Mottagare: Kontrollanter, kontrollantelever, CI alla klubbar	Datum: 2019-10-09	BilagService Bulletin	Blad nr: 1 av 1
Fastställt av MK: 2019-10-09		Ersätter:	
Utlärdare: SFF Materielkommitté (MK)		Ärende: Materielvarning nr. 2019/4

ISSUE DATE: March 30th 2019
Bulletin Number: FB 2019-01
SUBJECT: Reserve pin ripcord assemblies on Firebird EVO Harness Containers
STATUS: **MANDATORY BEFORE NEXT JUMP**
Affected HC: All Firebird EVO HC with Pillow Ripcord assemblies PN 012 built between April 2018-March 2019, Serial numbers BD 001-CB 010
To: All Firebird Dealers and Customers

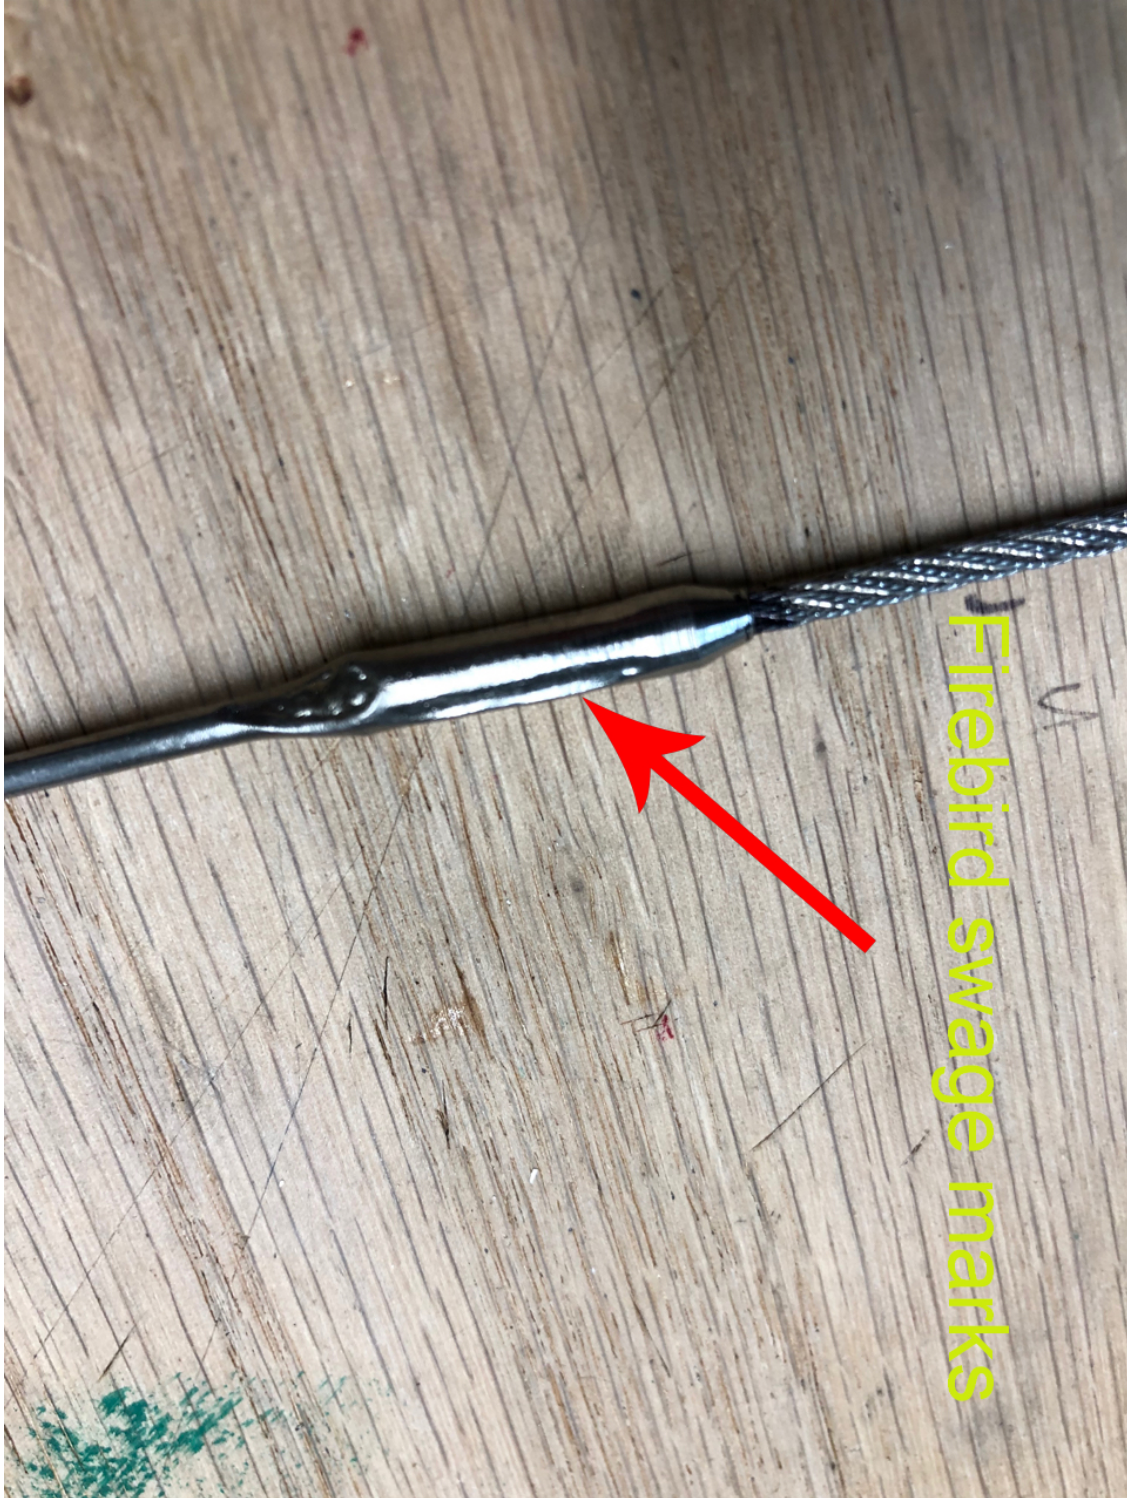
If your HC has a ripcord pillow ripcord assembly installed between SN BD001 and CB010 they have to be visually inspected for swaging marks.

If your reserve pin doesn't have clear swage marks as pictured, DO NOT JUMP until notification and further inspection through Firebird USA LLC.

MANDATORY visually inspection of the pin cable junction by a FAA certified Senior or Master Rigger (or national equivalent) before next jump.

Contact Firebird per phone +1 7473008880 to arrange shipping of a new ripcord at no charge. You can send us pictures per email at usa@flyfirebird.com. Furthermore, the supplier agreed to pull test any ripcord that any customer wants tested.
